# W13b

November 13, 2012

**SUBJECT:** Addendum to Staff Report for CDP Application E-12-005 and Consistency Certification CC-027-12, Pacific Gas & Electric Company See further additional correspondence received.

**EXHIBIT 6**  
 Morro Bay  
 Stock of  
 Harbor  
 Porpoise  
 Core Habitat

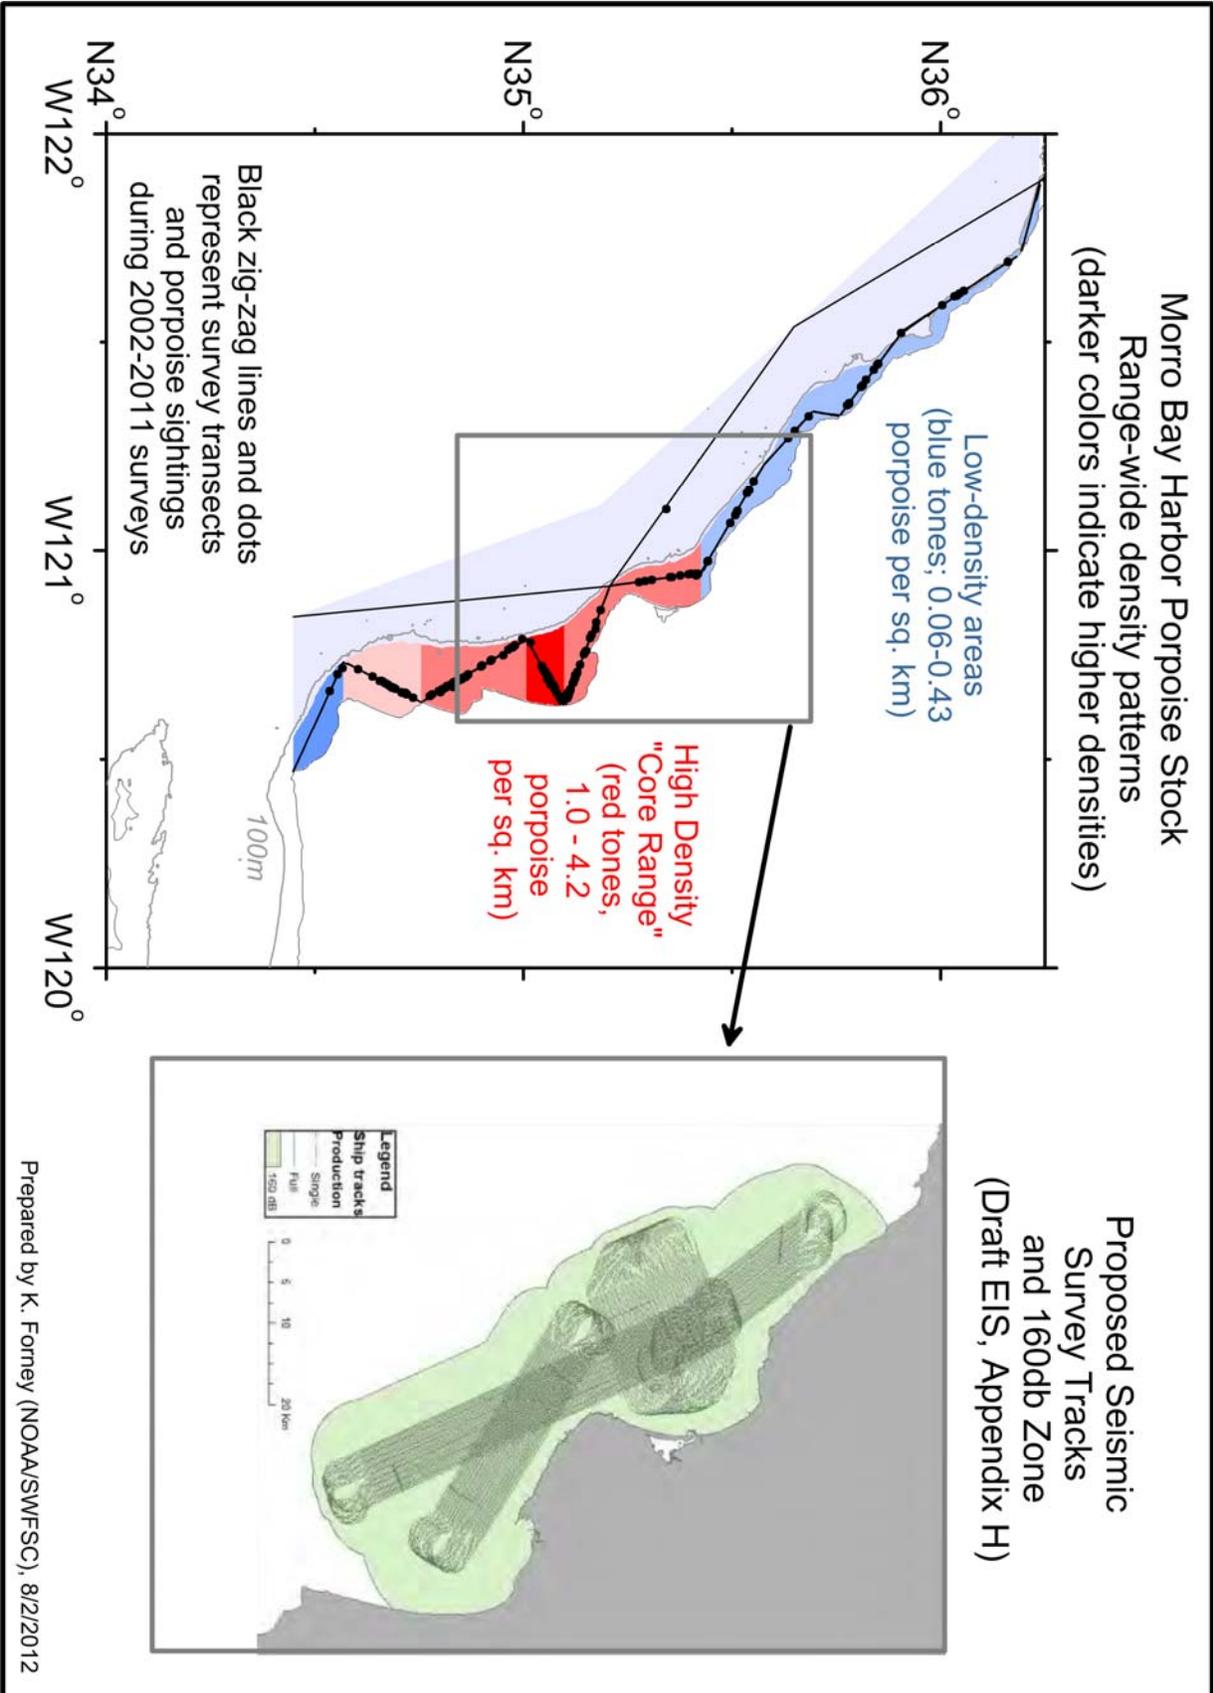
“To further illustrate the points raised above regarding the proposed conduct of active survey operations within the core habitat of the Morro Bay stock of harbor porpoise, Exhibit 6 includes a figure demonstrating the location of this core habitat area in relation to the proposed survey areas and a discussion of the genetic and geographic isolation of this stock from the 2011 U.S. Pacific Marine Mammal Stock Assessments developed by NMFS. This figure supports the assessment of Wood et al. (2012) and NMFS that the proposed project will have significant adverse effects on the Morro Bay stock of harbor porpoise. Marine mammal aerial surveys carried out in the project area on October 2, 2012, the results of which are also included in Exhibit 6, further support these conclusions and demonstrate that harbor porpoise are likely to be present within close proximity of the proposed active survey activities. **The survey would effectively close about half of the harbor porpoise core habitat area, and porpoises within that area seeking refuge from the survey would likely either move into the remaining core habitat, thereby increasing competition, or move to more marginal habitat areas.**”

**EXHIBIT 7a**  
 Expected  
 Sound  
 Propagation  
 Distances

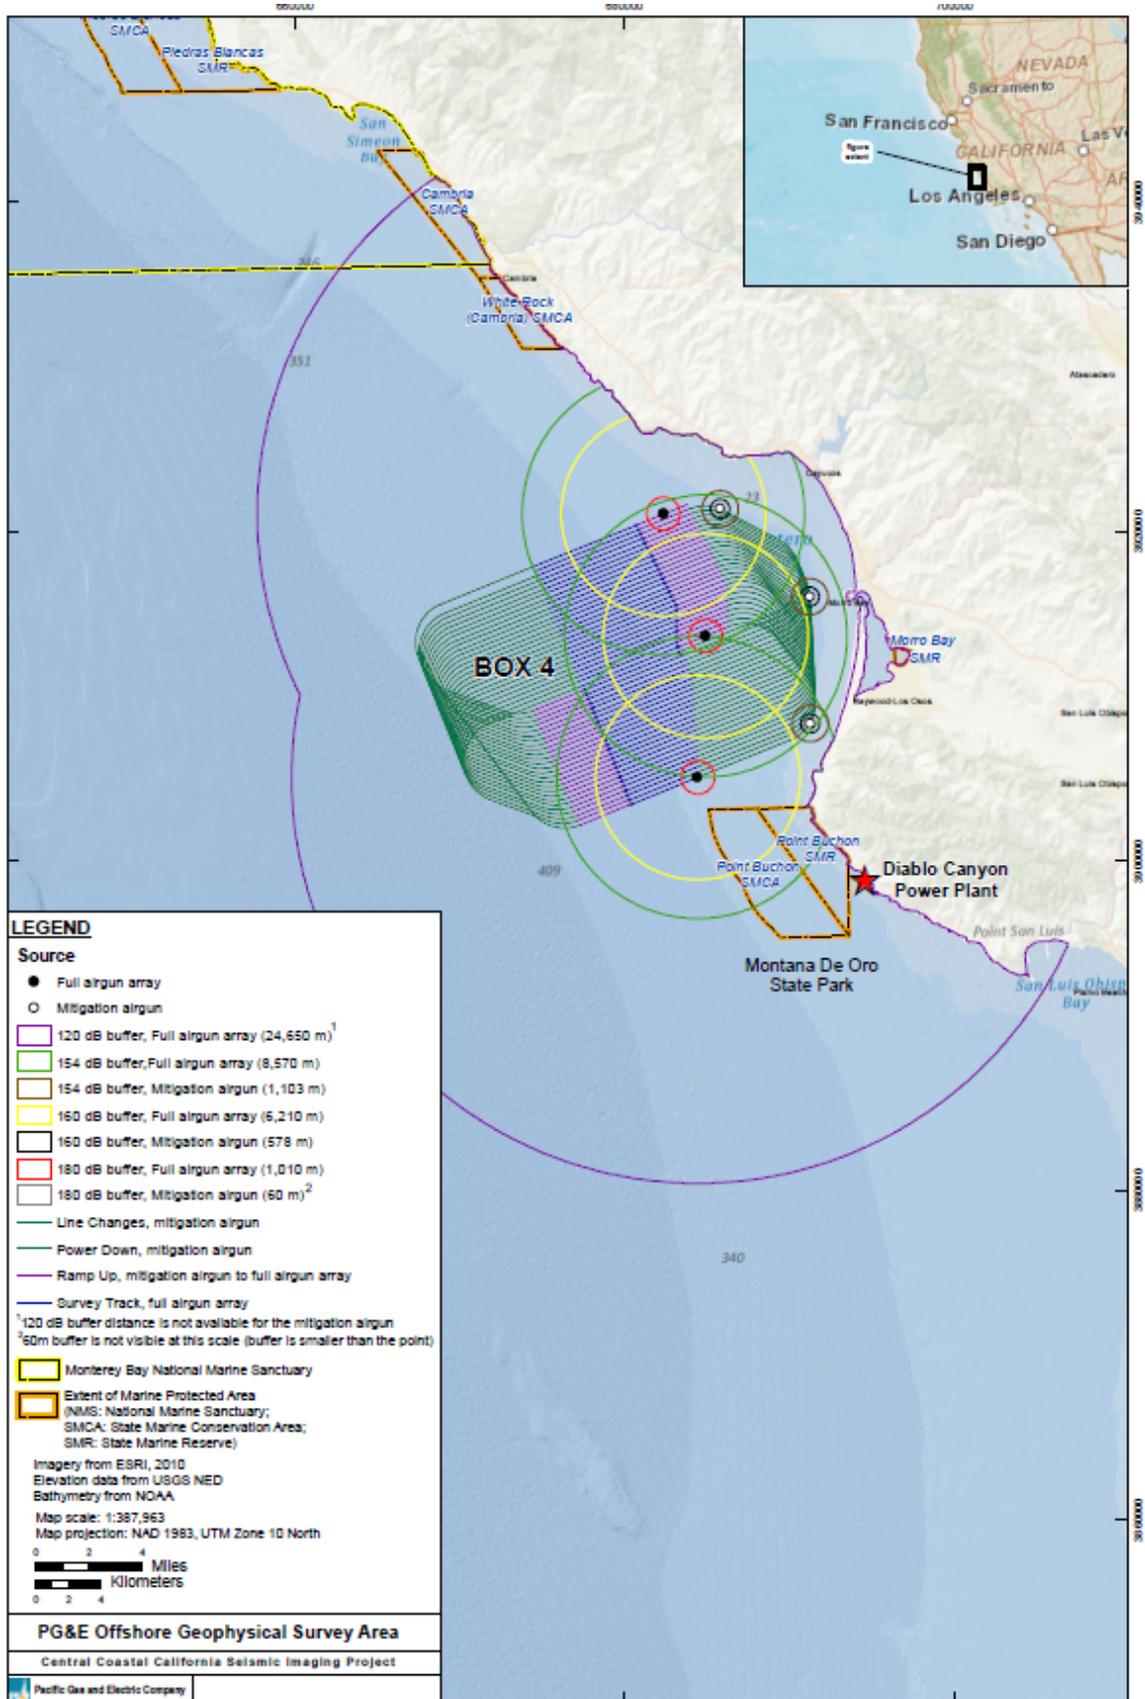
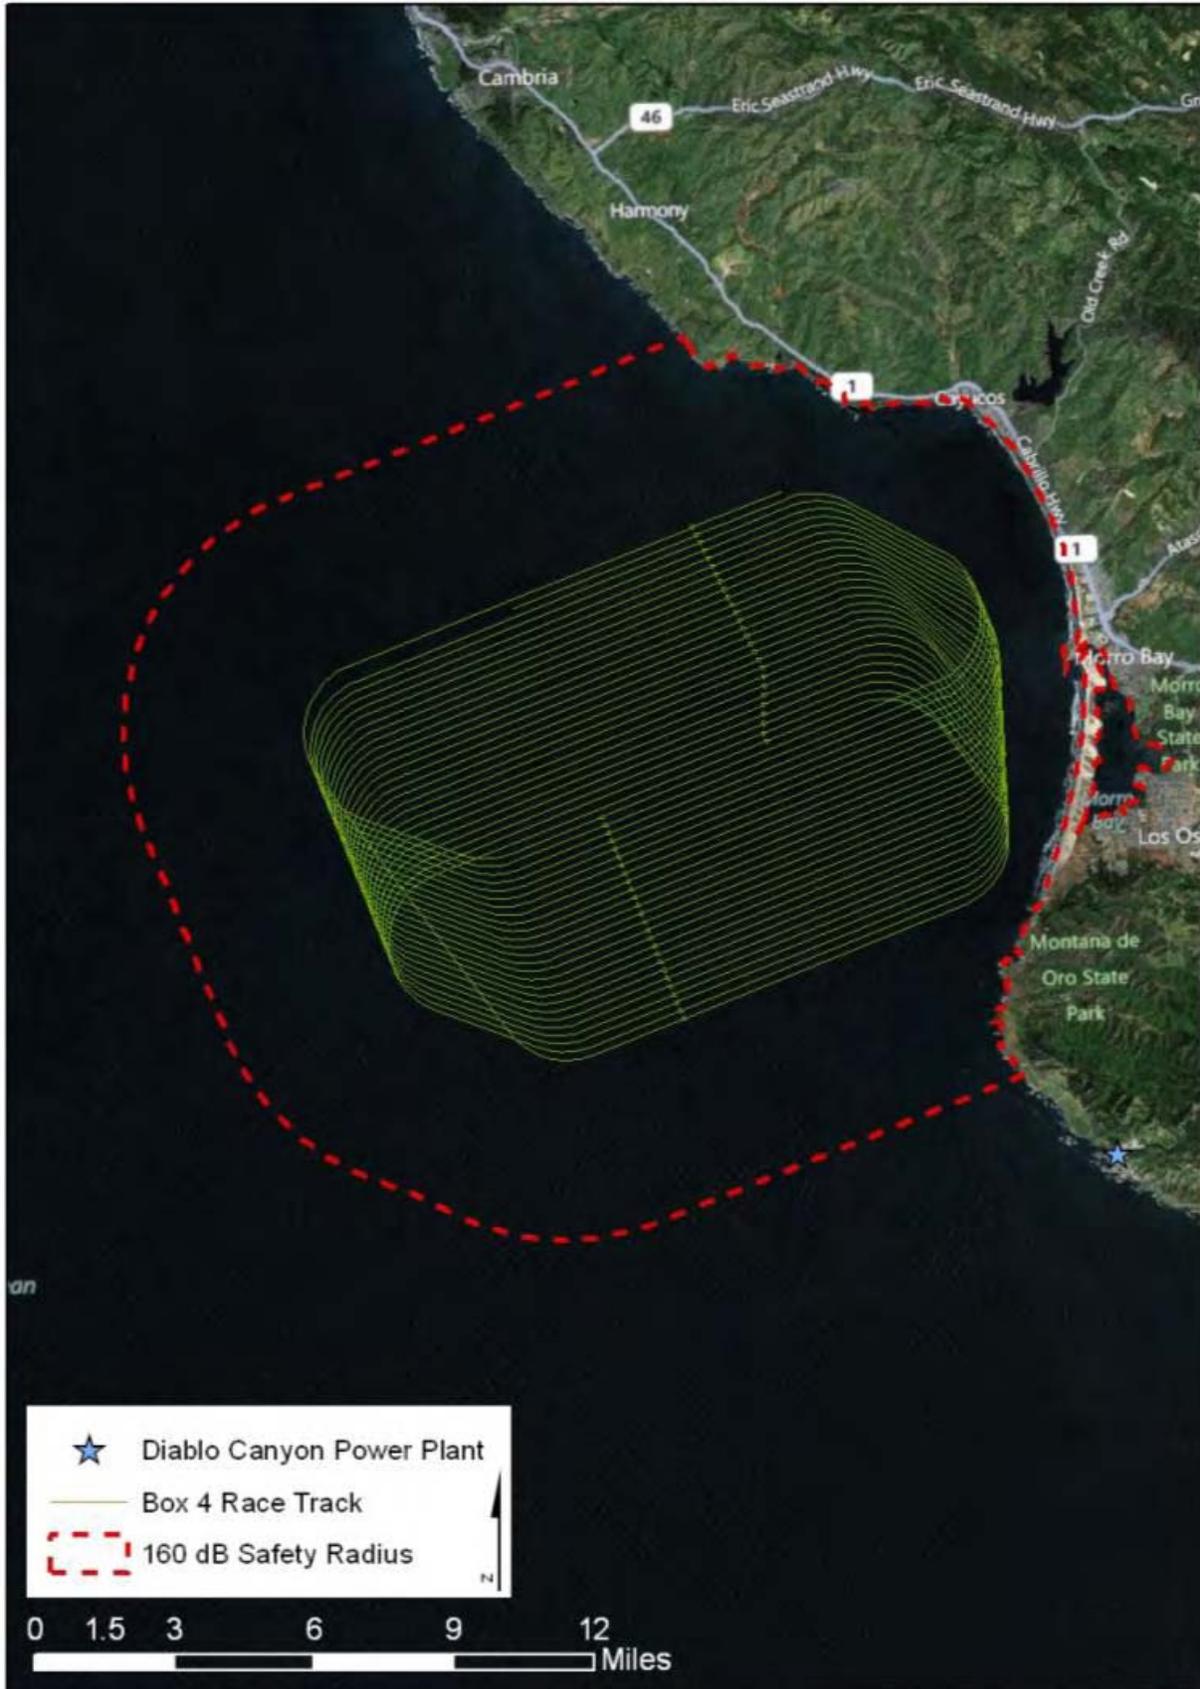
As noted above, PG&E submitted the figure included as [Exhibit 7](#) to demonstrate the anticipated sound propagation distances and received sound levels in beach areas throughout the project area. However, this figure does not accurately depict the anticipated sound levels that would be received in beach and coastal areas within the project area because the vessel locations from which the “full air gun array” sound propagation distances are calculated are further offshore than the survey vessel would be when it begins firing of the full air gun array. As discussed in a letter provided to the Independent Peer Review Panel on October 19, 2012, the full air gun array would begin firing as soon as the vessel completes each turn:

This would substantially increase the received sound levels in nearshore waters along the coast from Montana de Oro State Beach to Cambria beyond those depicted in the figure provided in [Exhibit 7](#). Received sound levels would be expected to exceed 160 dB throughout this area during the proposed survey activities, with the highest levels received each time the survey vessel approaches or completes one of its shoreside turns. Additionally, the sound propagation distances depicted in the figure above are based on the modeled behavior of underwater sound waves in the project area. Until five day sound source verification process is completed at the initiation of active survey operations, the actual sound levels and distances will not be known with complete certainty. As such, the received sound levels in nearshore areas may further exceed or fall short of modeled expectations.
